SPECIFICATION CONTROL DRAWING

DESIGN		DART AEROSPACE LTD	
DRAWN		HAWKESBURY, ONTARIO, CANADA	
CHECKED		DRAWING NO.	REV. B
MFG. APPR.		D4002	SHEET 2 OF 2
APPROVED		TITLE	SCALE
DE APPR.		HOSE ASSEMBLY	NTS
DATE	10.11.03	COPYRIGHT © 2010 BY DART AEROSPACE LTD THIS DOCUMENT IS PRIVATE AND CONFIDENTIAL AND IS SUPPLIED ON THE EXPRESS CONDITION THAT IT IS NOT TO BE USED FOR ANY PURPOSE OR COPIED OR COMMUNICATED TO ANY OTHER PERSON WITHOUT WRITTEN PERMISSION FROM DART AEROSPACE LTD.

D4002-1 HOSE ASSEMBLY

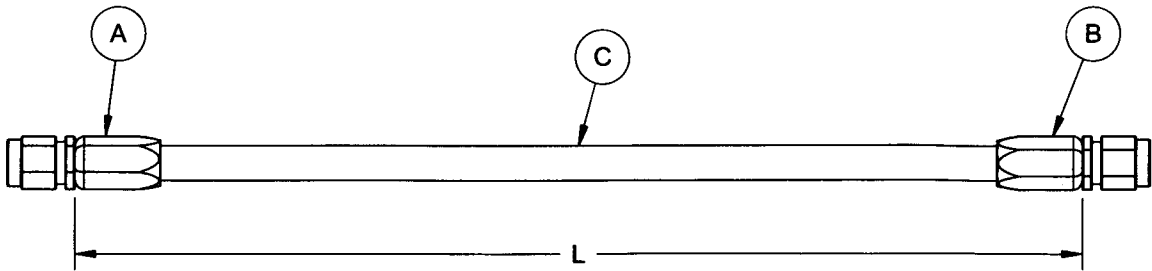
ADD IN 8.00" TO
-1/-3 FOR COMPATIBILITY

W/ EUROCOPTER SQUARE CHECK
